October 29, 2010

Alex Baker
Lighting Program Manager, ENERGY STAR
U.S. Environmental Protection Agency

Re: ENERGY STAR Luminaires Draft 2 Comments

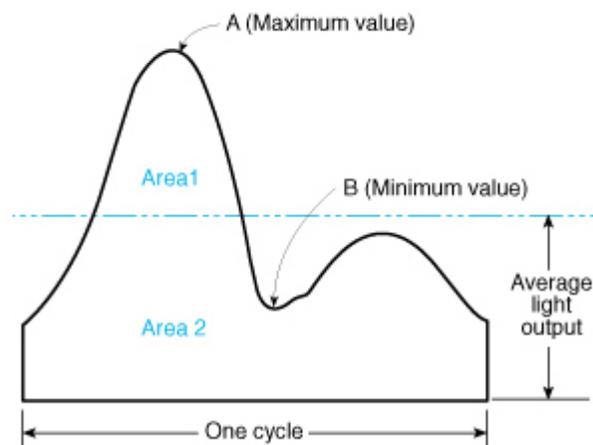
Issue One: The use of modulation depth is an obsolete standard, abandoned by the IES for a more meaningful Flicker Index. Flicker Index is defined by the relationship of luminance area above average to total area as follows (from IES Handbook 9):

Calculation: $\text{Area 1} / (\text{Area 1} + \text{Area 2}) = \text{Flicker Index}$

A flicker Index of “0” is the highest rating achievable, with a rating of “1” being the worst. Photometric data collected by LTL (Grather 2009) indicates an incandescent lamp has a flicker index of roughly .0194, while a Metal Halide Lamp has a flicker index of 0.1398, and a T12 fluorescent lamp on magnetic ballast operates with a flicker index of 0.0897.

Based on this, a maximum Flicker Index of 0.130 should be established.
